Electrical diagram using TPS40055

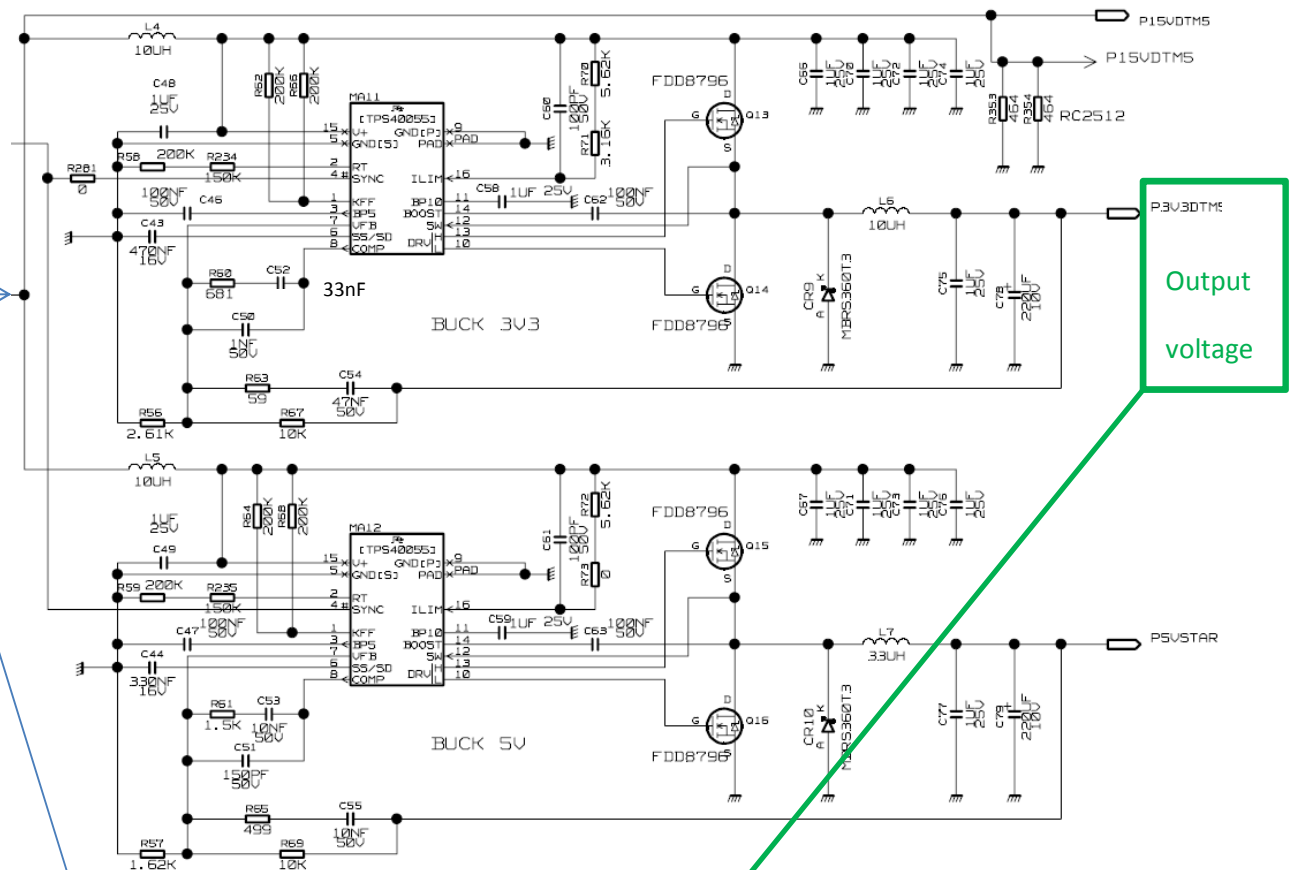
At cut off, during the following edge of the 15V power supply, an over voltage occurs on the 3V3 output. In some case, this overshoot exceeds the steady state voltage 3.3V, up to 3.45V.

At this time, the input voltage is approximately 6 volts.

What could be the root cause? How could we prevent this overvoltage?

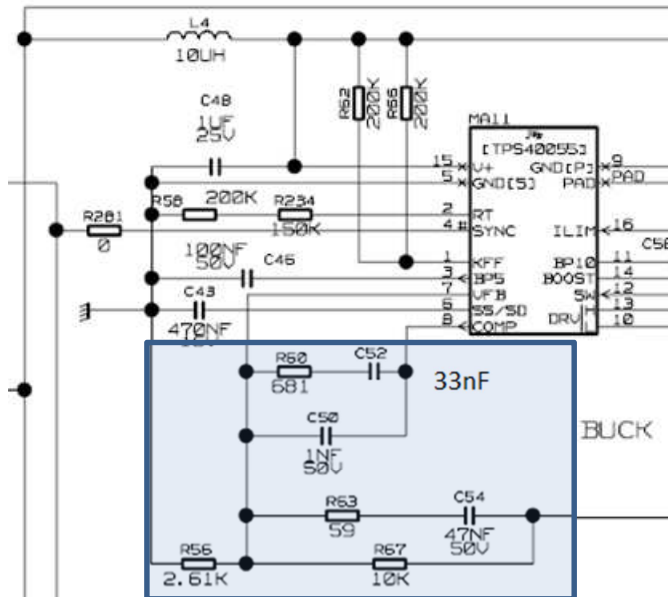
We have tried to act on the feedback. And, the better finding compromise is with the following values.

With these, phase margin is the following : 89° at 5.07KHz. Acceleration of the dynamic, above 5Khz, have a wrong impact on the overvoltage at cut off.
